November 8, 2019 BOARD OF COUNTY COMMISSIONERS ORANGE COUNTY, FLORIDA Y20-719-TA / ADDENDUM # 5

EASTERN REGIONAL WATER SUPPLY FACILITY - SODIUM HYPOCHLORITE SYSTEM CONVERSION TO BULK

This addendum is hereby incorporated into the bid documents of the project referenced above. The following items are clarifications, corrections, additions, deletions and/or revisions to and shall take precedence over the original documents. <u>Underlining</u> indicates additions, deletions are indicated by <u>strikethrough</u>.

50-LCP-5 PLC Panel (04/29/16 version)

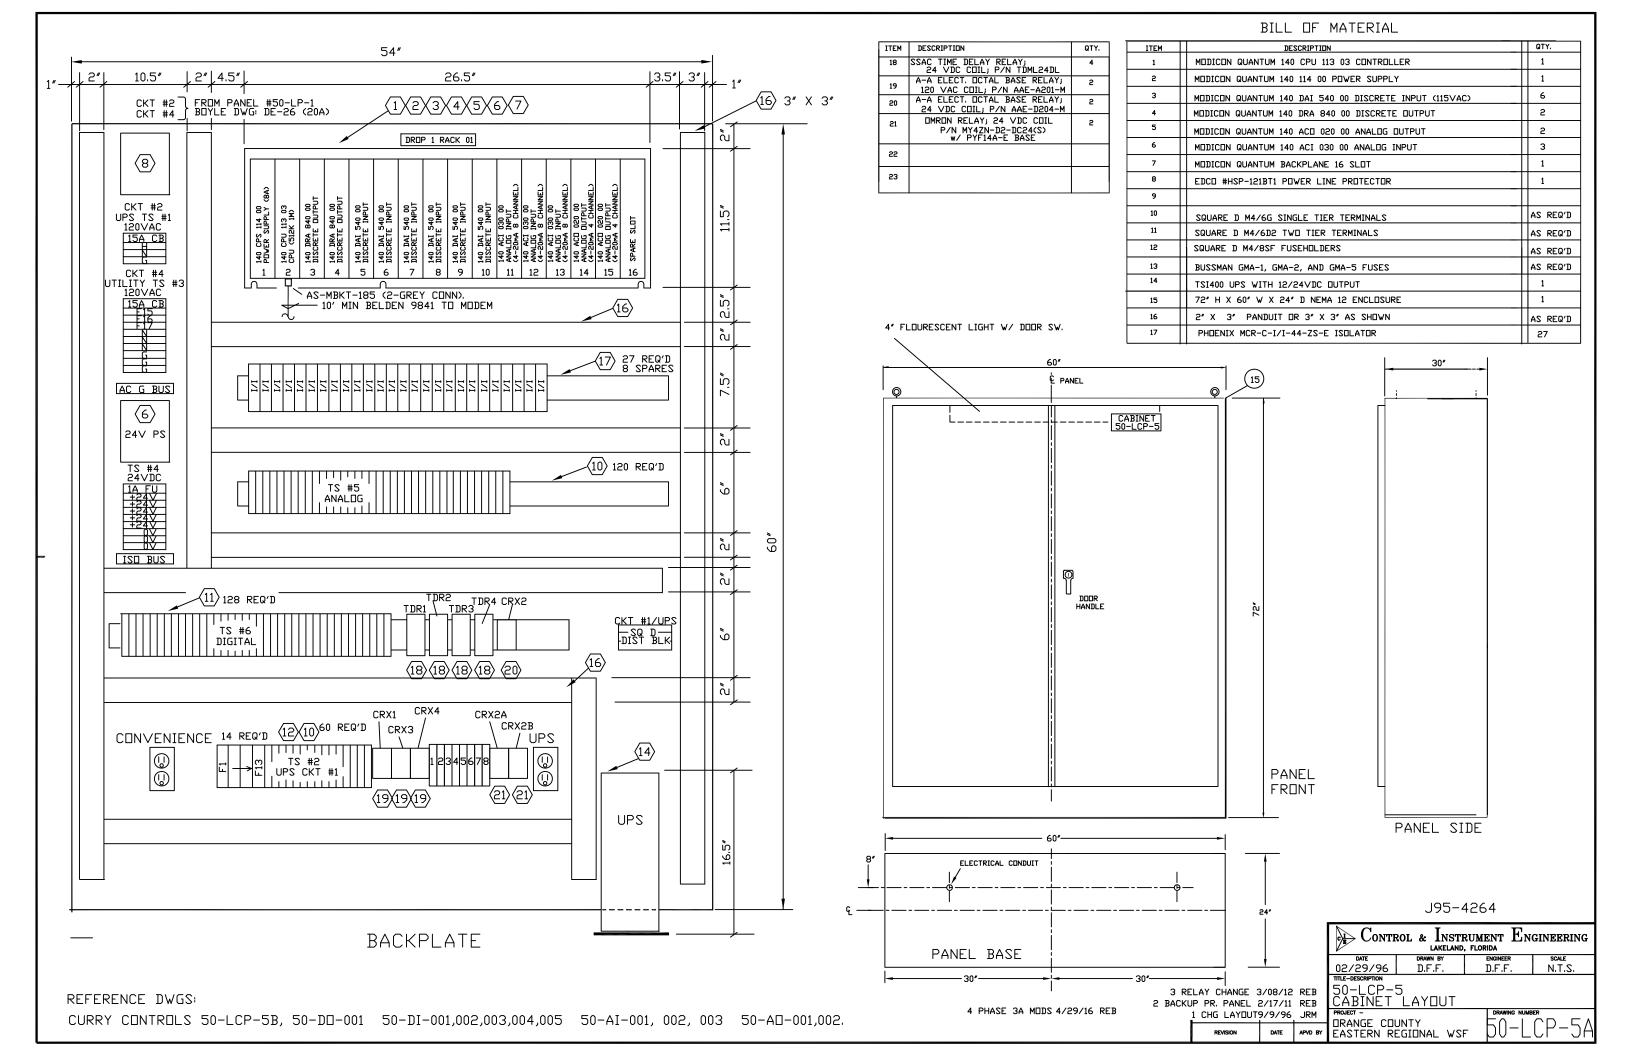
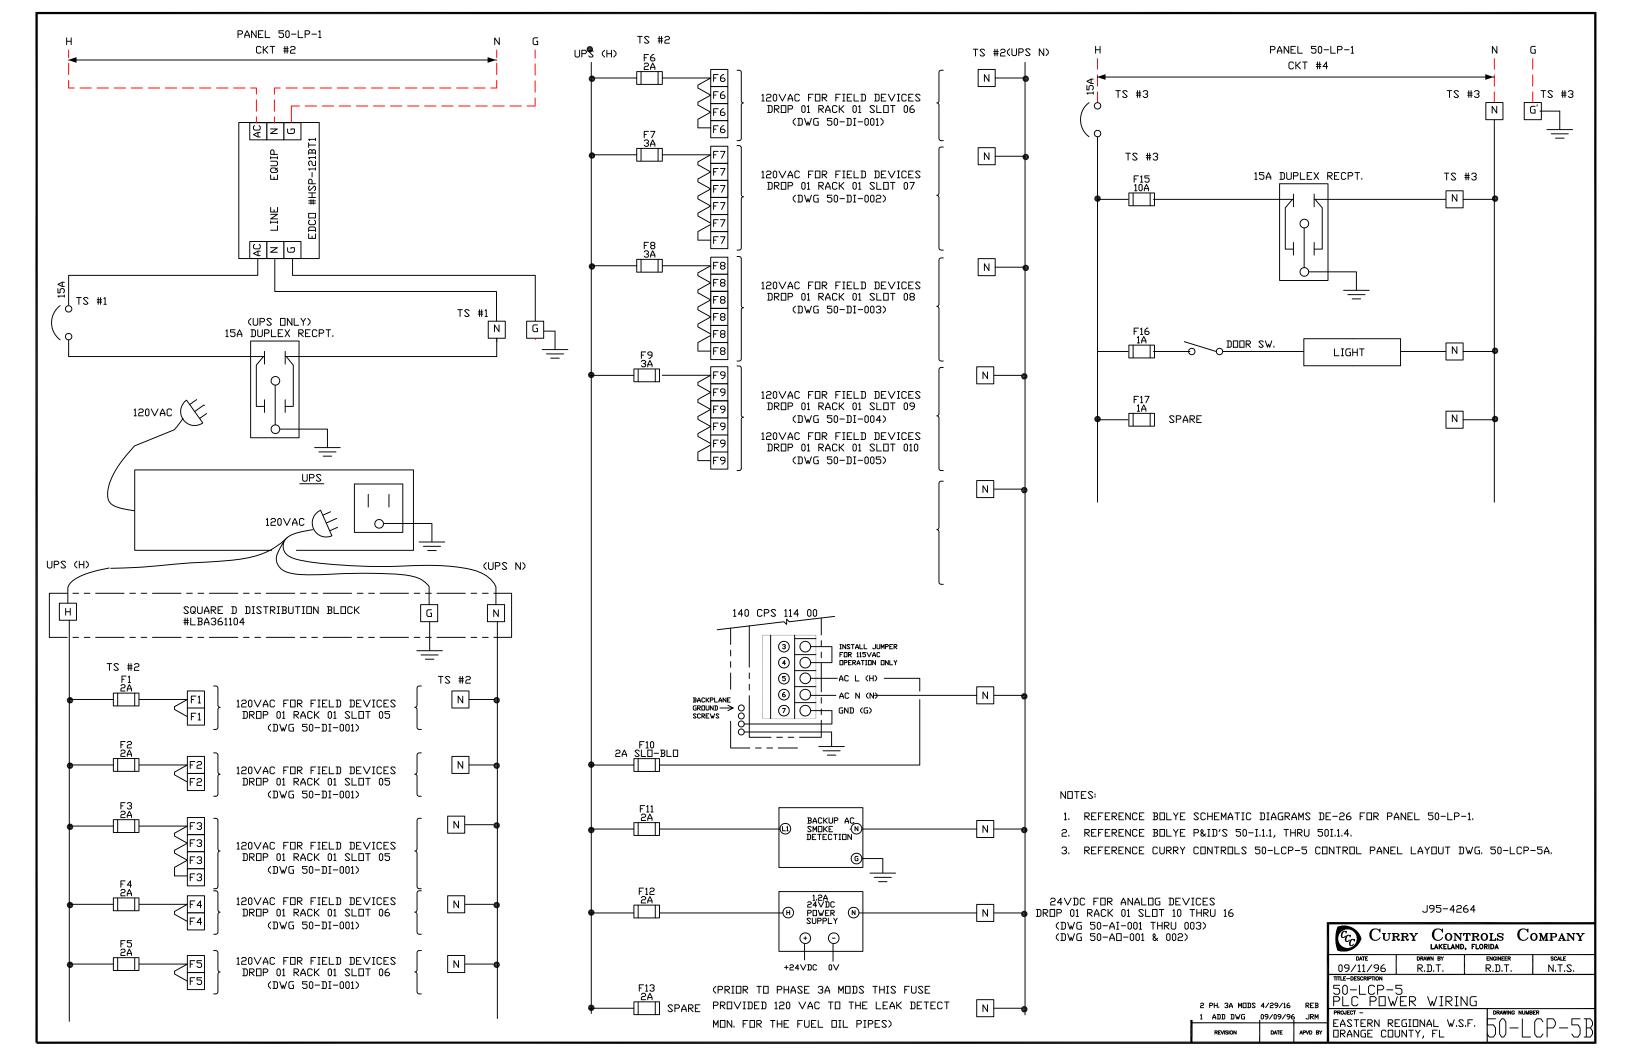
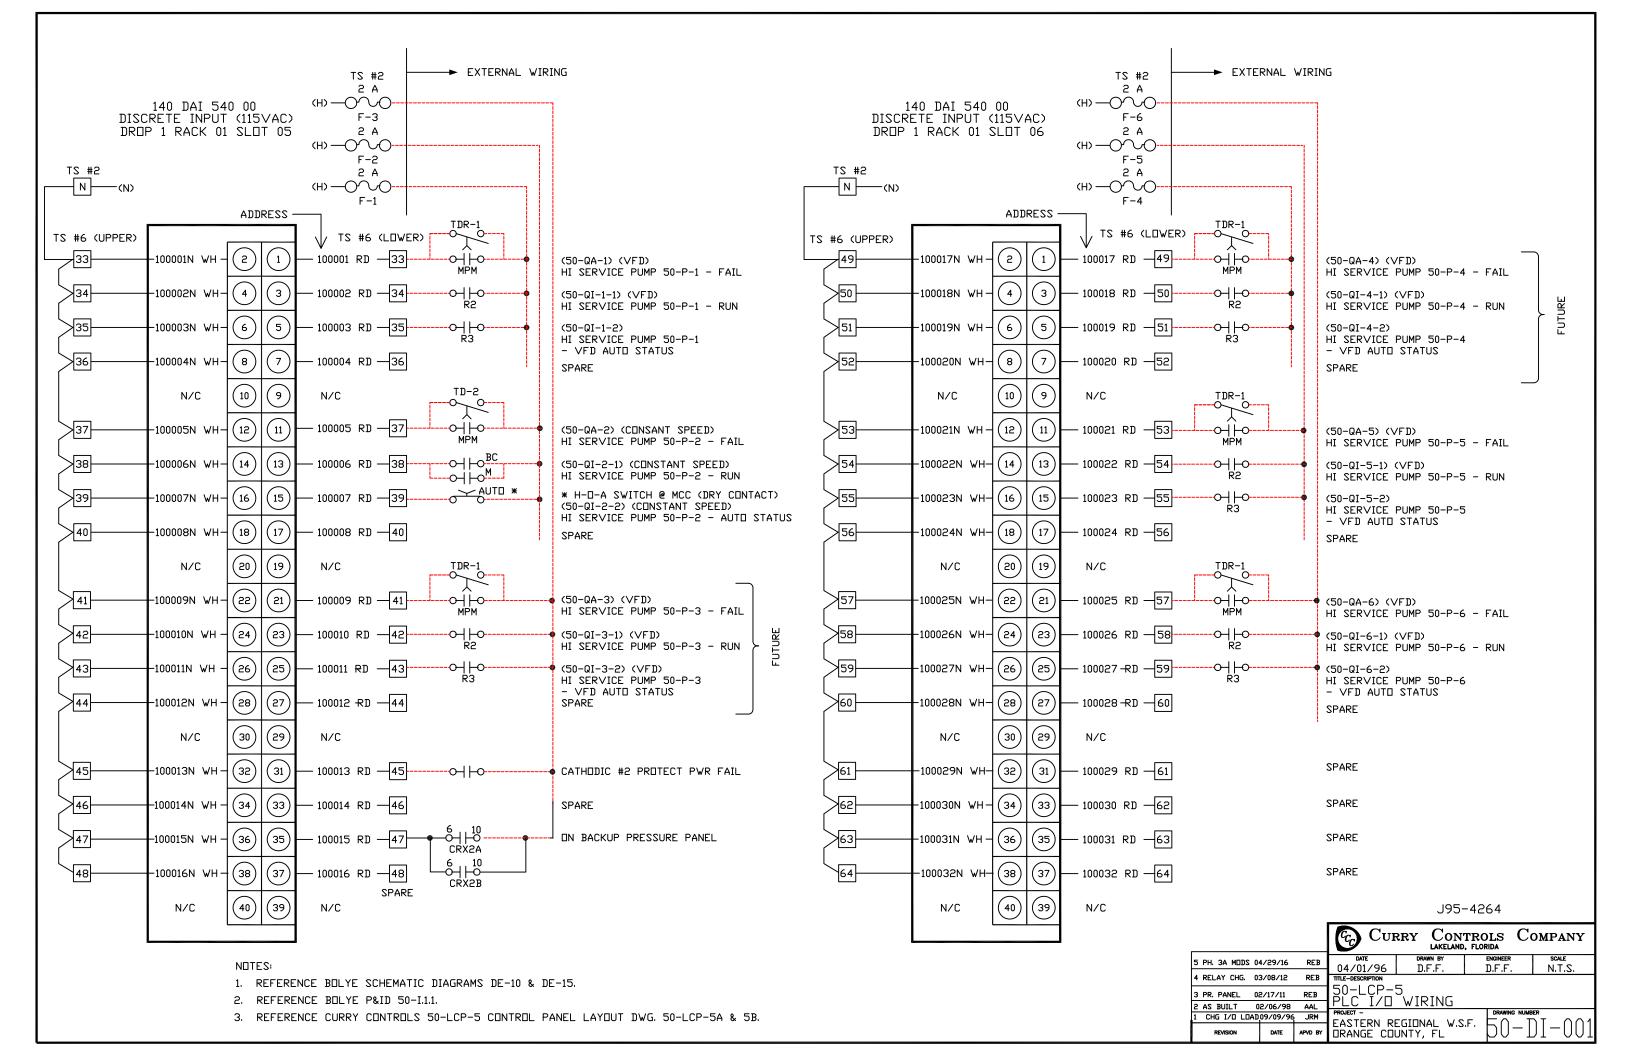
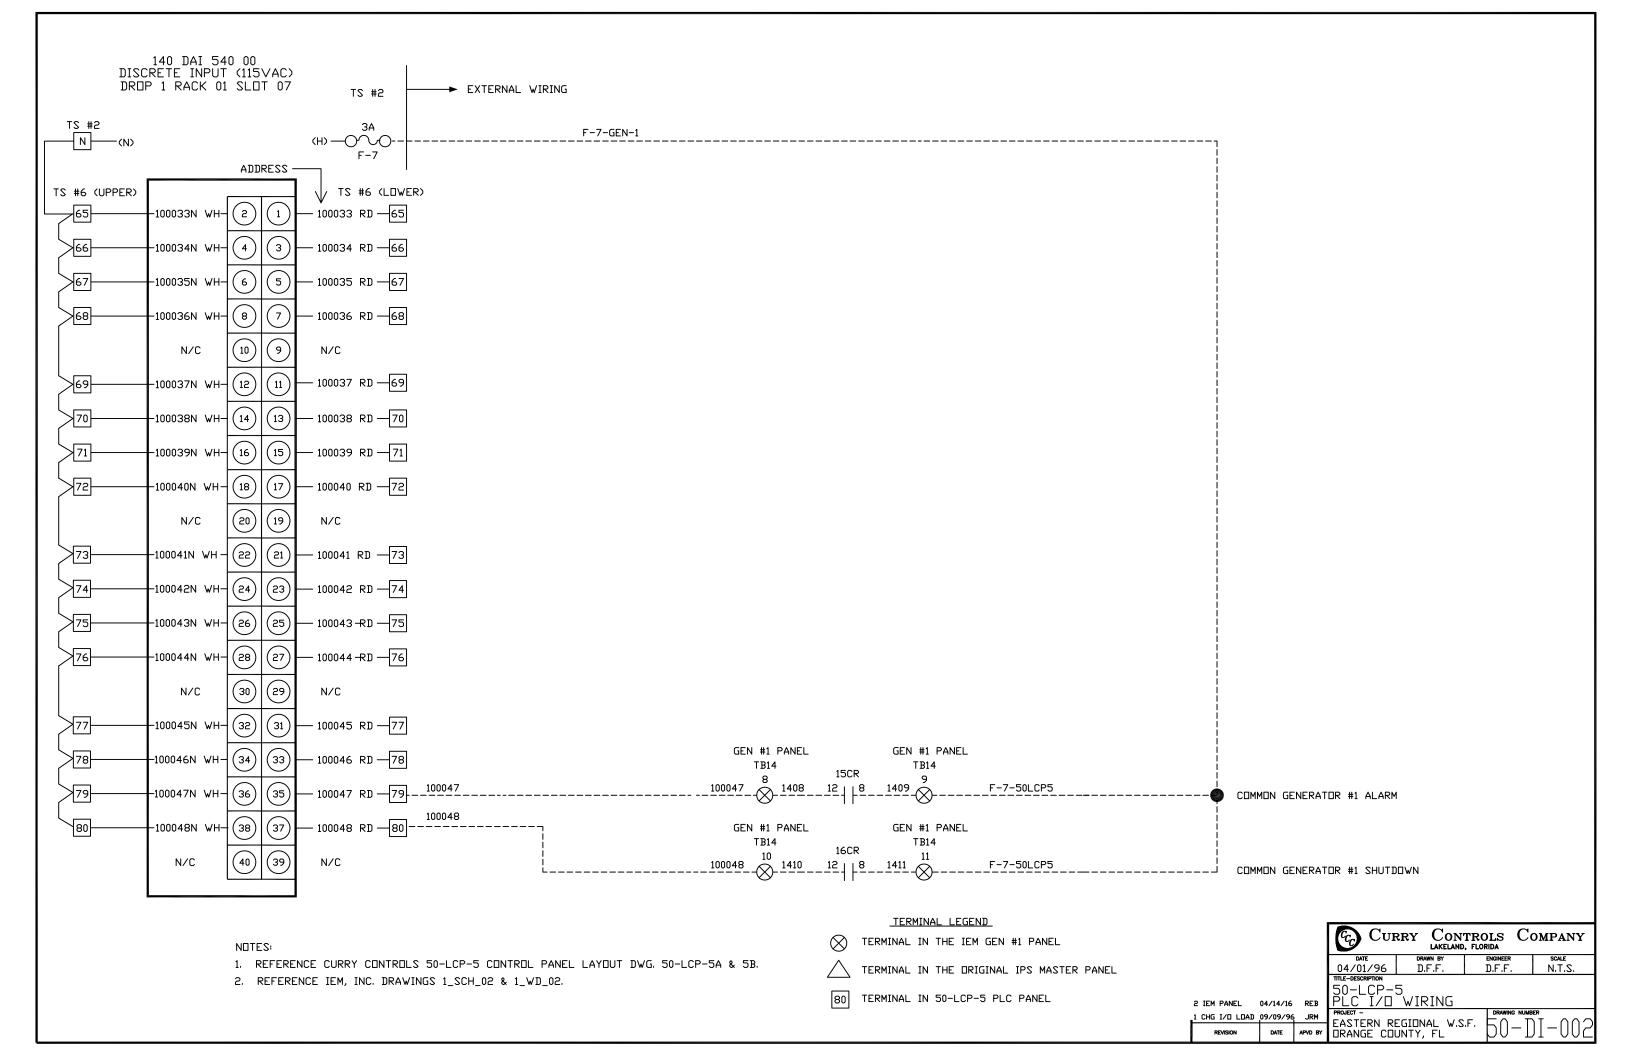
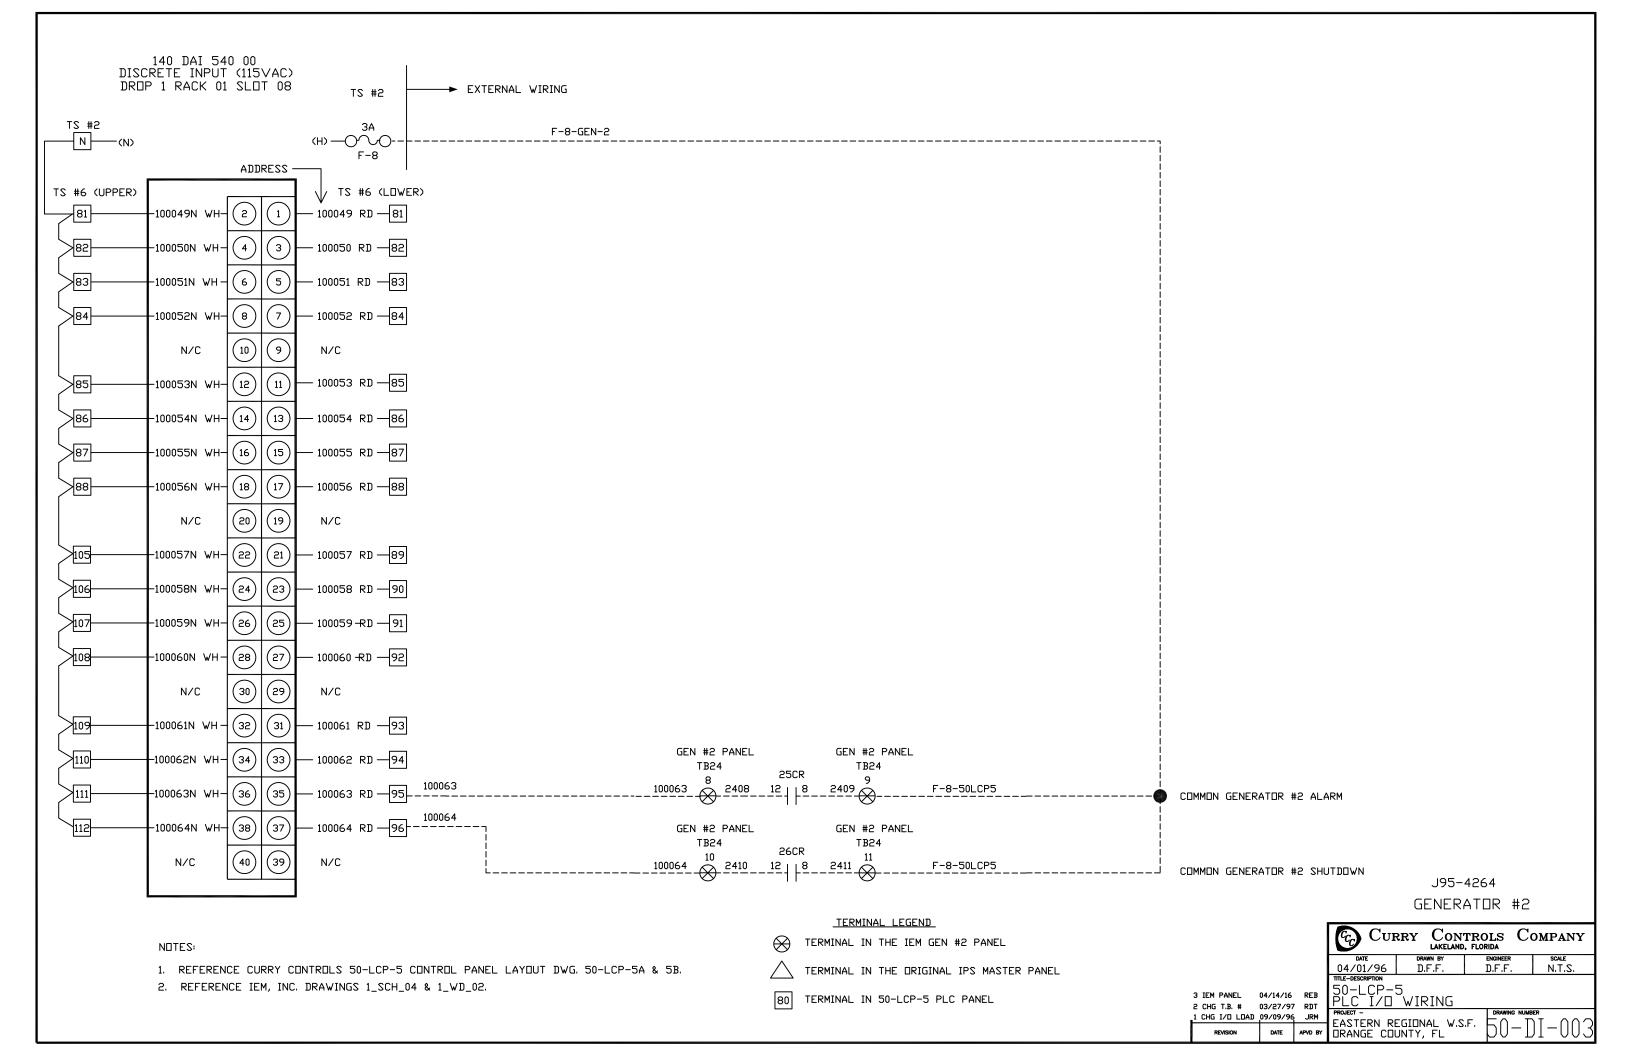
The communications between 50-LCP-5 & RIO-5 appears to be Ethernet over fiber. The existing (and specified) Quantum PLC platform does not support remote I/O over Ethernet. The platform does support CPU-to-CPU communications over Ethernet, however the specified CPU is obsolete as referenced in the prior question. Please clarify the communications between 50-LCP-5 & RIO-5.

- A: CPU shall be Schneider M580. Refer to Specification modifications provided below in Part B of this addendum.
- 4. Q: Can the county provide the drawings for control panel 75-LCP-8 and 50-LCP-5?
